## Land Use Application Updates (per 2/28/23 email)

LAND USE APPLICATION  
3/10/2023

AREA PLANS AND UNIT SCHEDULE

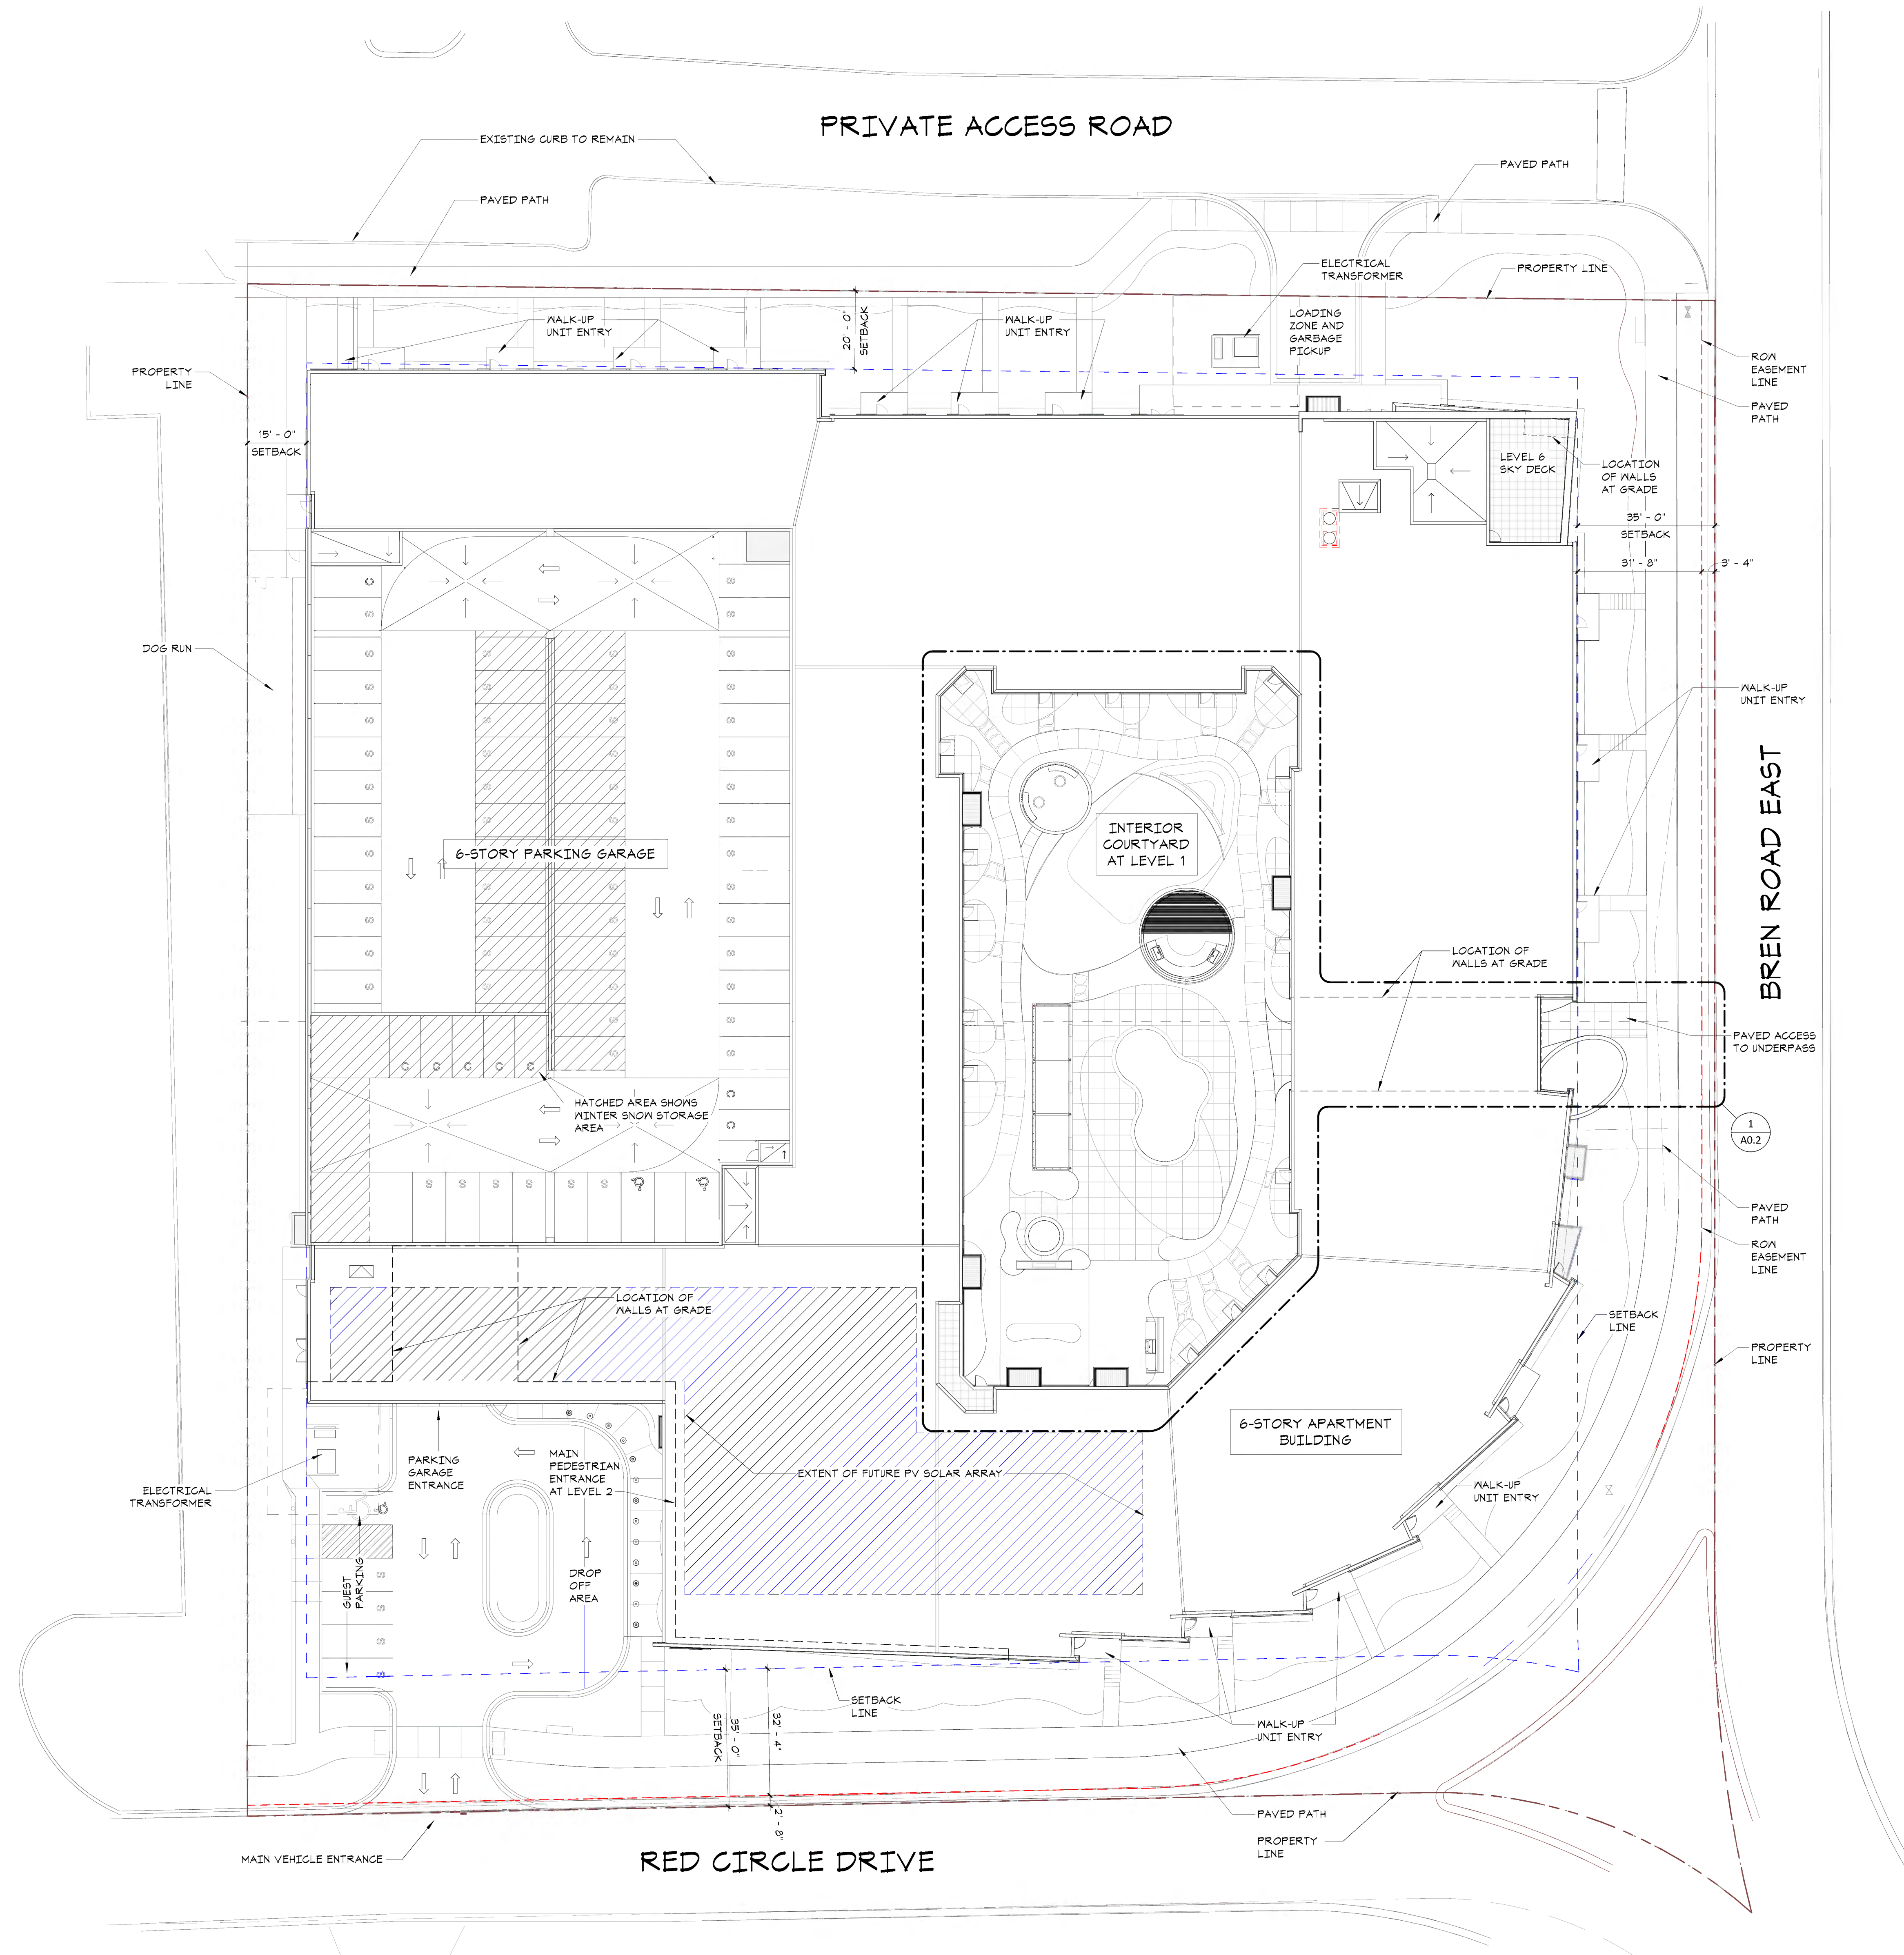
**Area and unit count plan:** The square footage of the various uses in the building need to be accurate in order to calculate water demand and sanitary sewer flow projections. Update, and include the other uses (office, amenity, institutional, etc.), and distinguish how the square footage is split between the north and south connections. The following is a screenshot of the area and unit count plan which suggests that the square footage may not be accurate: **The area schedules have been updated to reflect the differing use sizes and the unit count of 275. See tables on sheet A1.0.**

STUDIO	SQ. FT.	UNITS
UNIT S1	1,953 SF	5
UNIT S1.1	381 SF	1
UNIT S2	2,041 SF	5
UNIT S3	7,387 SF	10
UNIT S3.1	415 SF	1
	12,177 SF	22
Grand total: 272	236,550 SF	272

ROOF PLAN  
**A1.6**

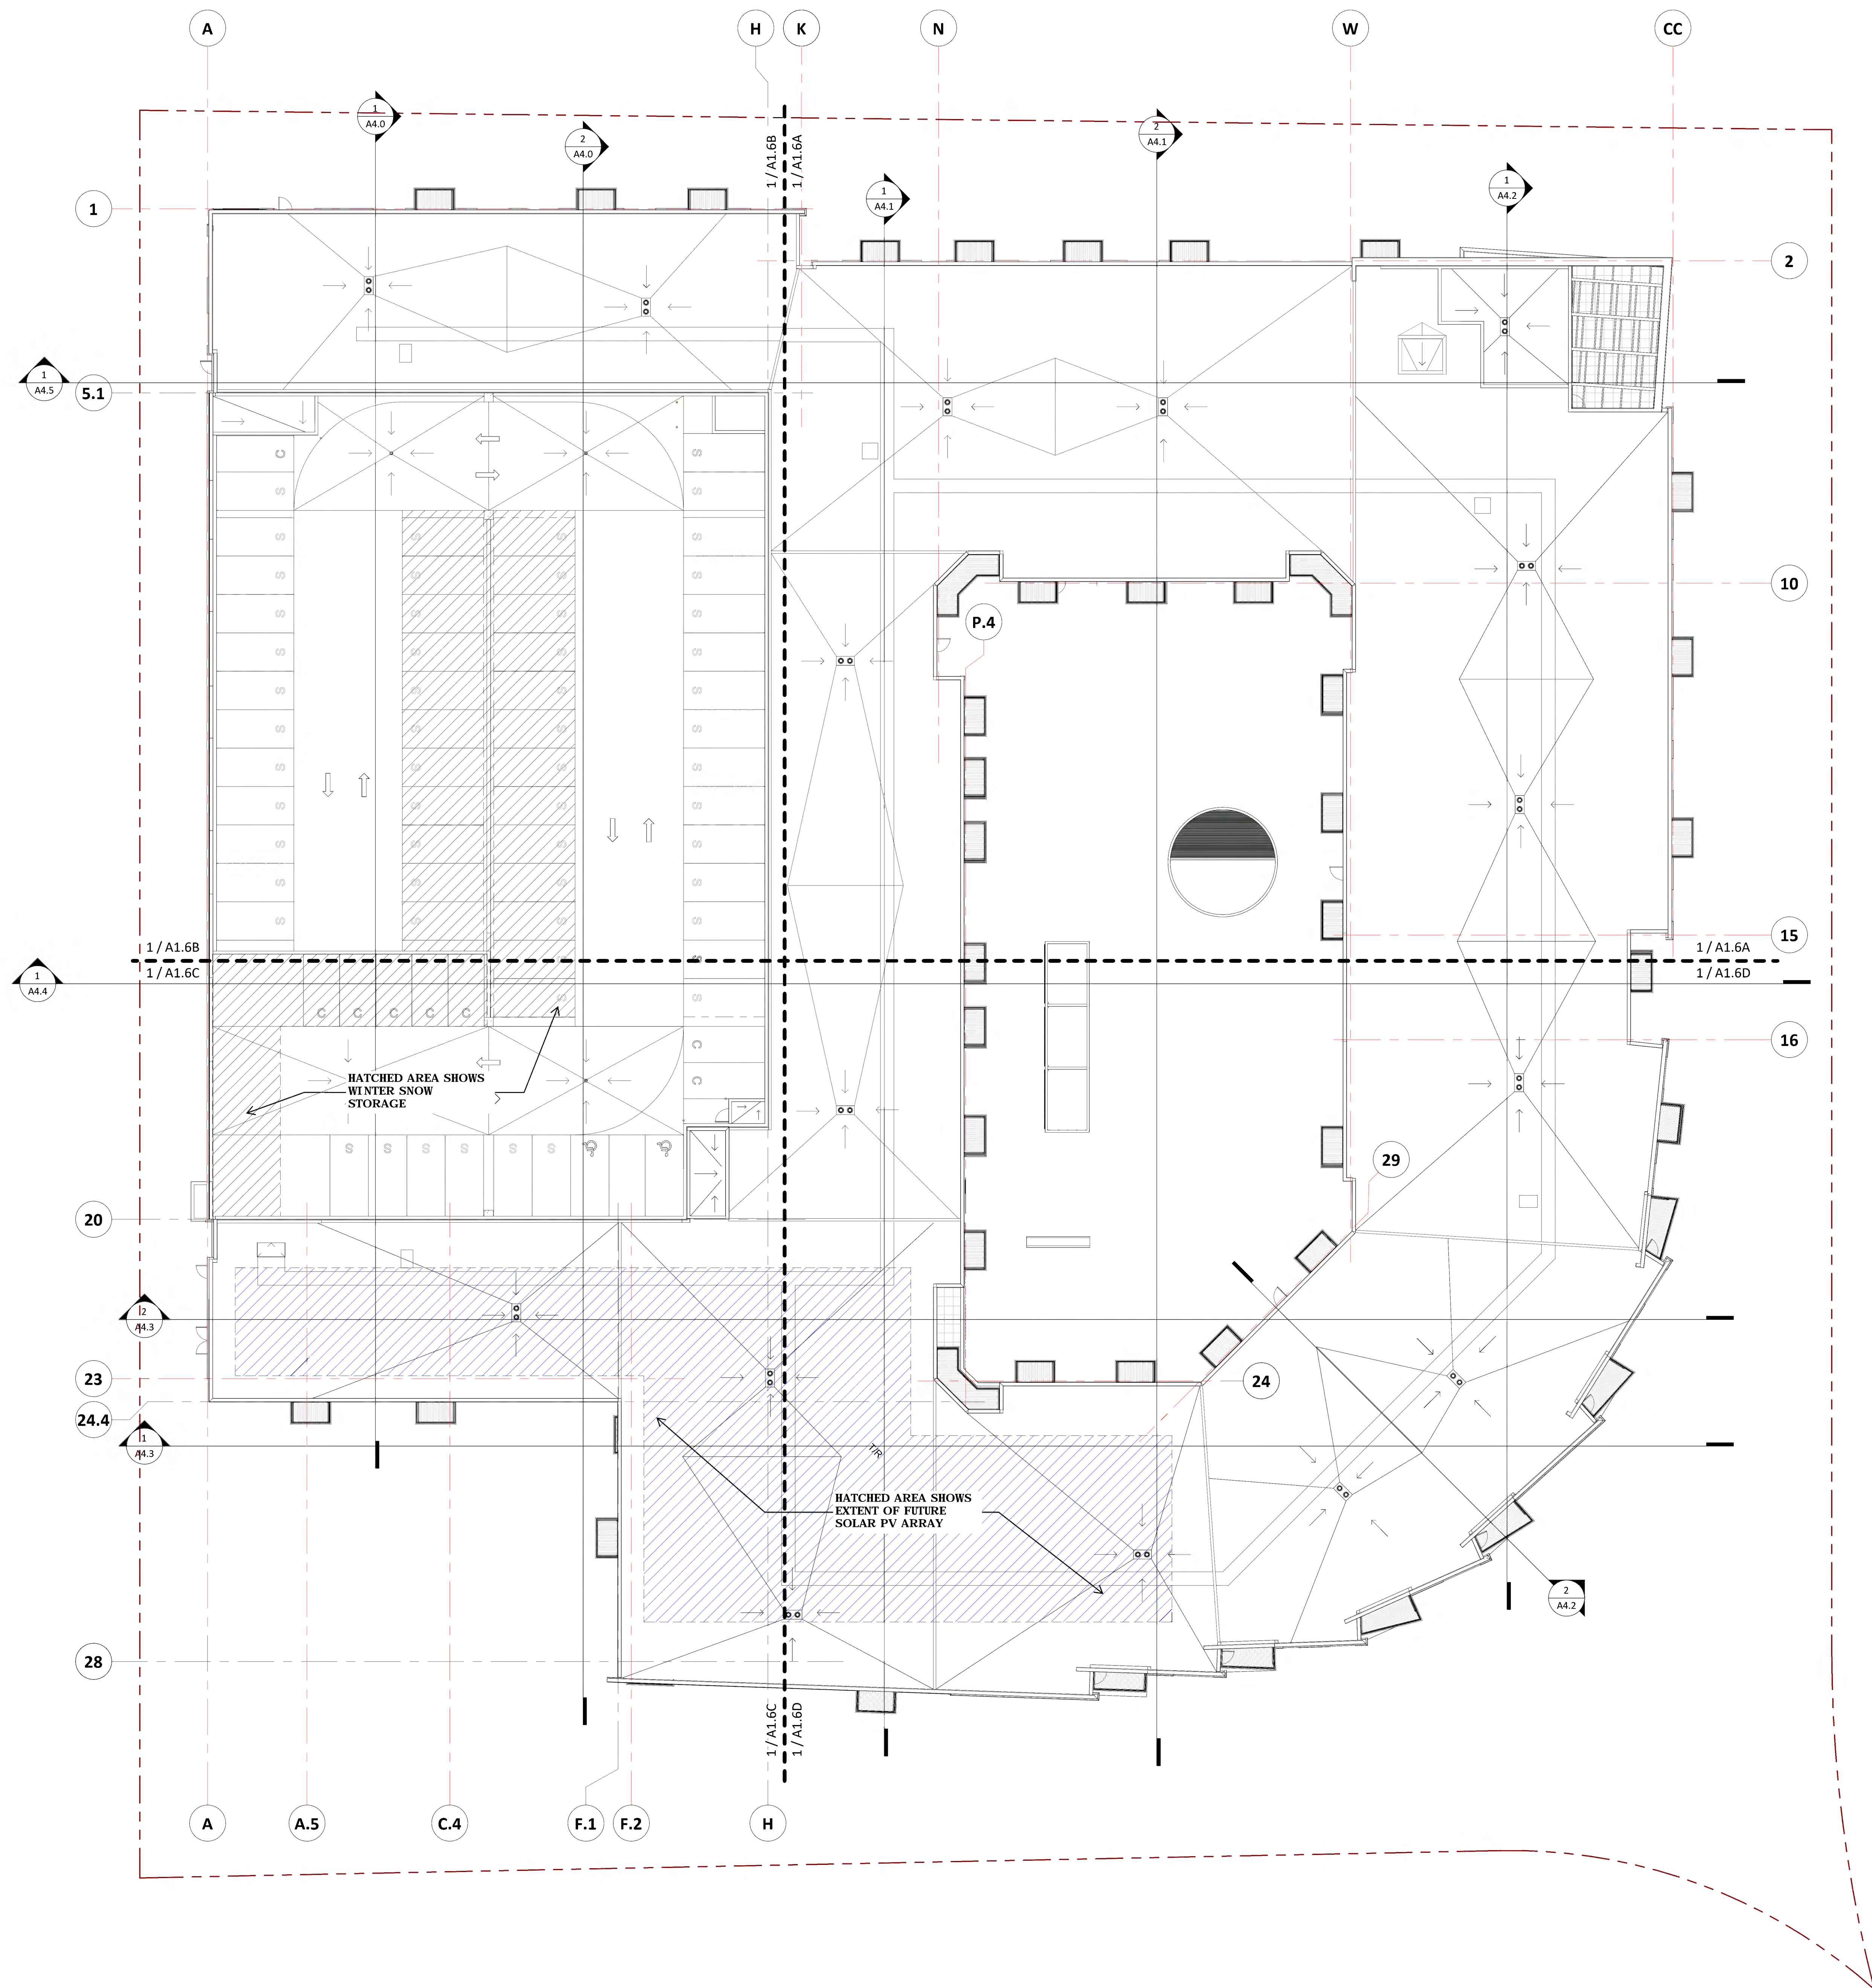
- **Roof:** Confirm the material and color of the roof. Initially, it was indicated that the roof would be solar ready, but the illustrations suggest a pea rock coating. **Showing PV solar area on architectural site plan A0.1 and sheet A1.6**

- **Snow removal plan:** A snow removal plan will be required as a condition of approval. This plan will need to include how snow will be removed from the ramp. Has consideration been made to how snow will be removed from the ramp, especially from the top floor. **See sheets: A0.1 and A1.6**
